ADMINISTRATIVE AMENDMENT

SHADE STRUCTURE HORIZONTAL CONTROL POINTS

CITY OF ALBUQUERQUE / FAMILY & COMMUNITY SERVICES
SINGING ARROW COMMUNITY CENTER

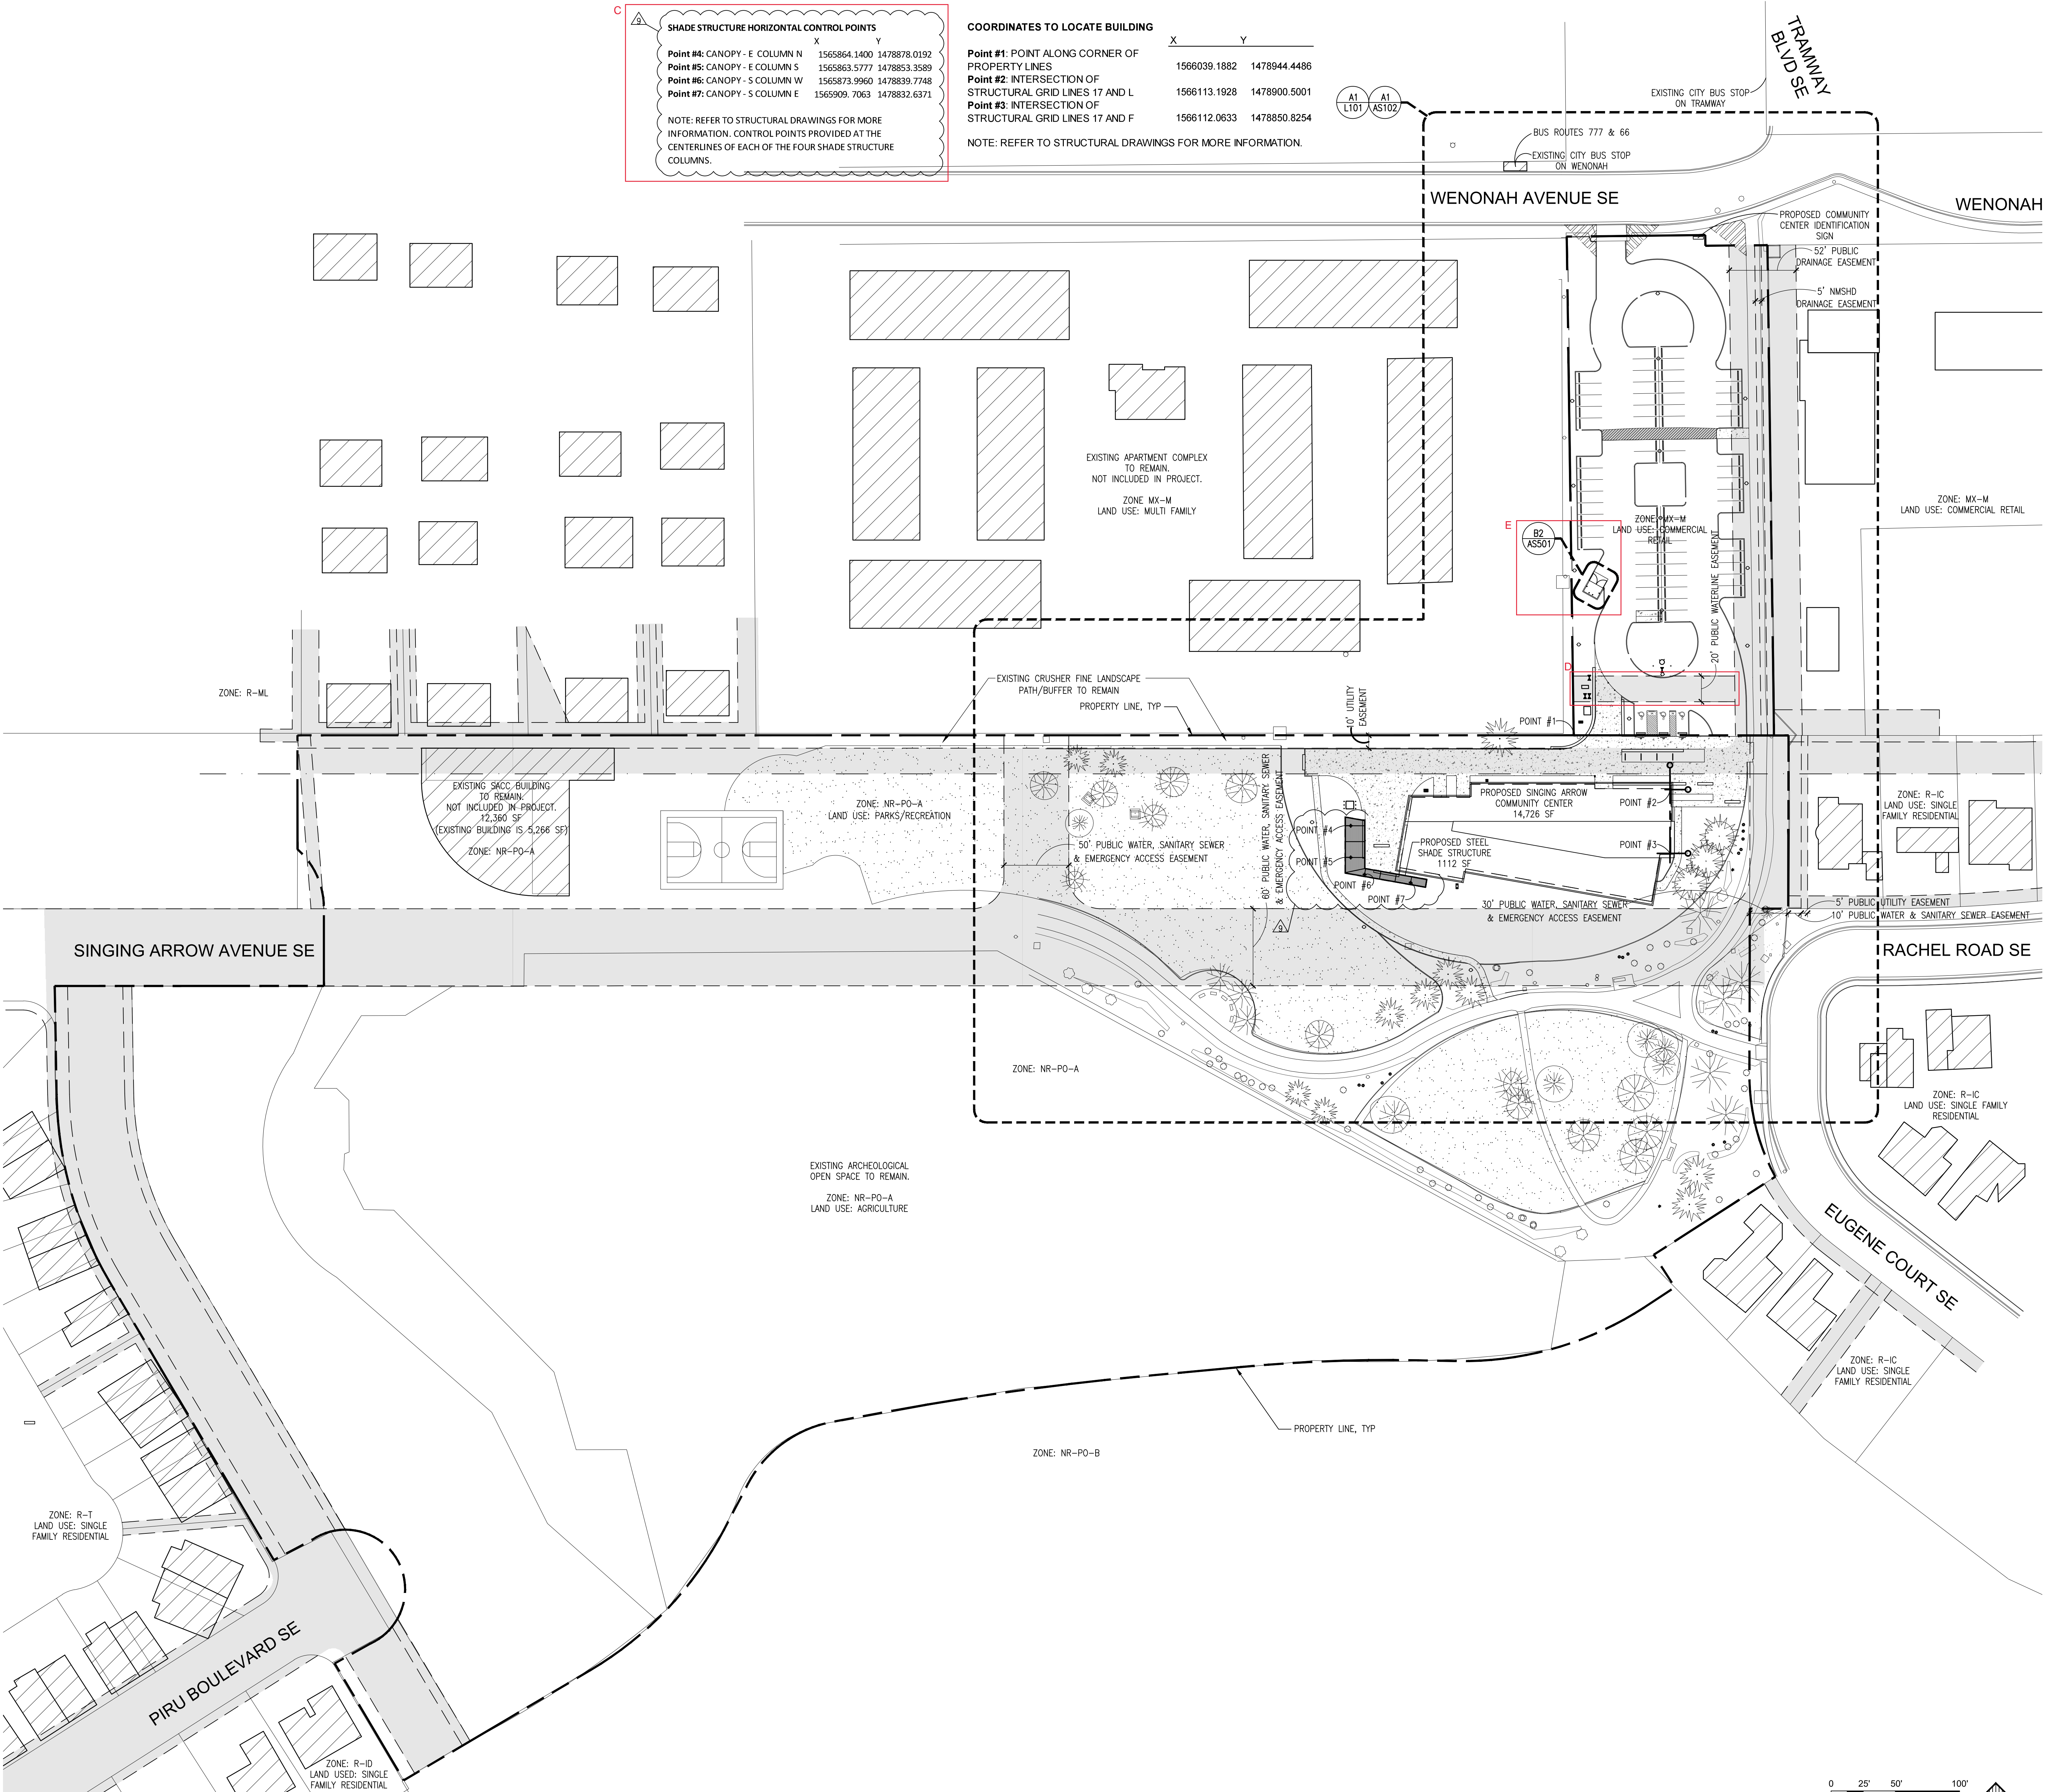
Point #	Column	X	Y
Point #4	CANOPY - E COLUMN N	1565864.1400	1478878.0192
Point #5	CANOPY - E COLUMN S	1565863.5777	1478853.3589
Point #6	CANOPY - S COLUMN W	1565873.9960	1478839.7748
Point #7	CANOPY - S COLUMN E	1565909.7063	1478832.6371

NOTE: REFER TO STRUCTURAL DRAWINGS FOR MORE INFORMATION. CONTROL POINTS PROVIDED AT THE CENTERLINES OF EACH OF THE FOUR SHADE STRUCTURE COLUMNS.

C1 WEST ELEVATION (ORIENTED TO WEST FACADE)
A-201

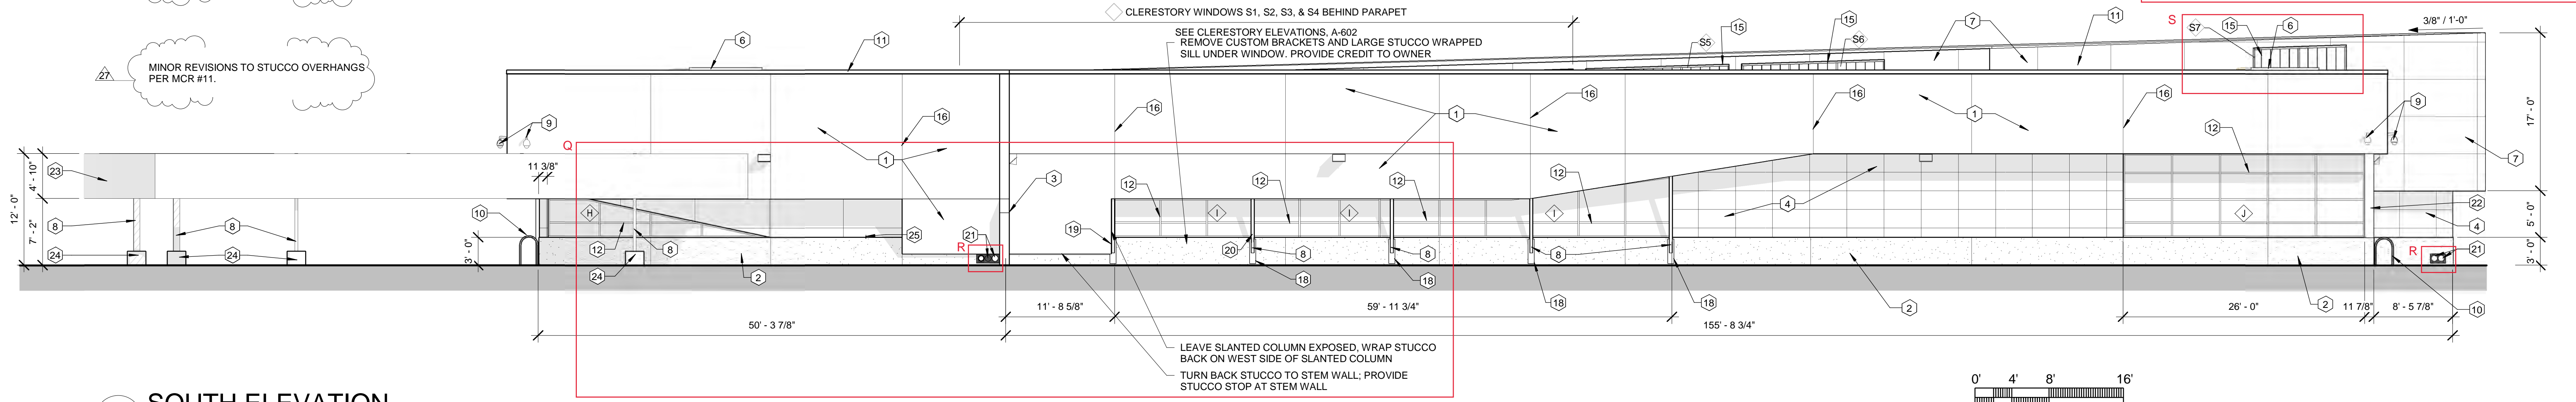
- 12 STUCCO AND CONCRETE CONTROL JOINTS UPDATED PER ASI #12REV.
- 27 MINOR REVISIONS TO STUCCO OVERHANGS PER MCR #11.

PARTIAL SITE PLAN

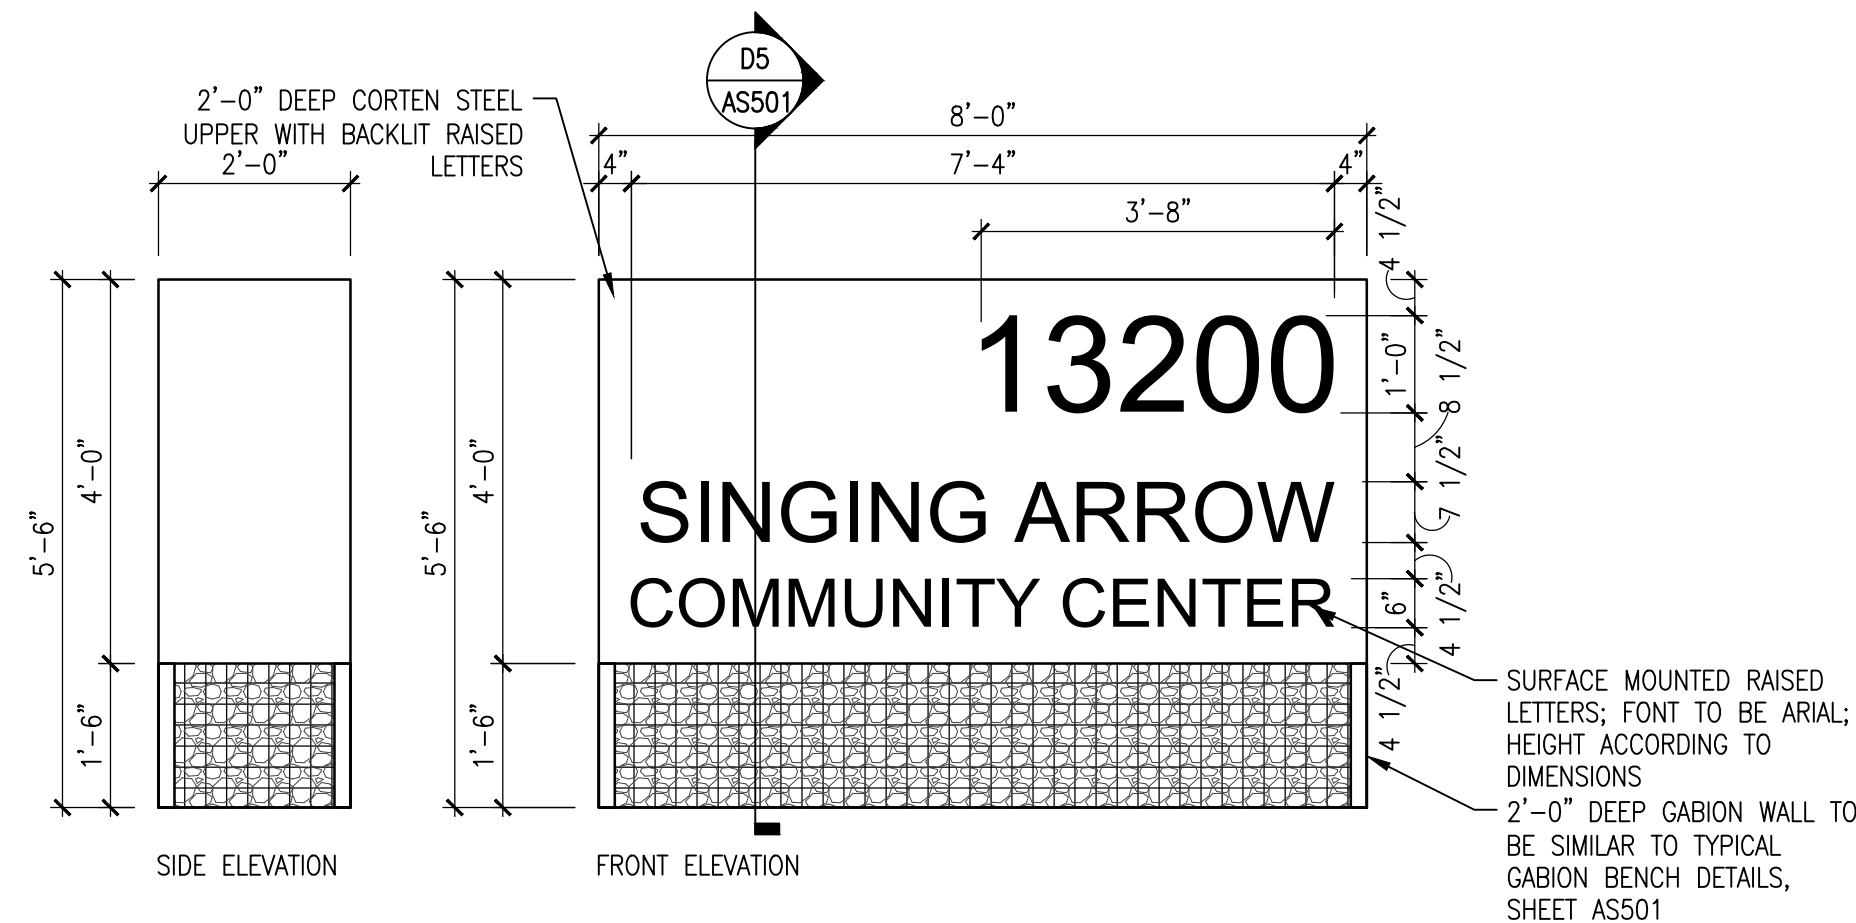
REMOVE TWO EXISTING TREES TO COMPLETE GRADING

REMOVE GABION BENCHES FROM INDICATED AREAS (50 LF OF GABION BENCHES REMOVED). RELOCATE GABION BENCHES AT SOUTH AND WEST SIDES OF CONCRETE (50 LF OF GABION BENCHES RELOCATED)

DELETE DASHED PORTION OF CONCRETE SLAB
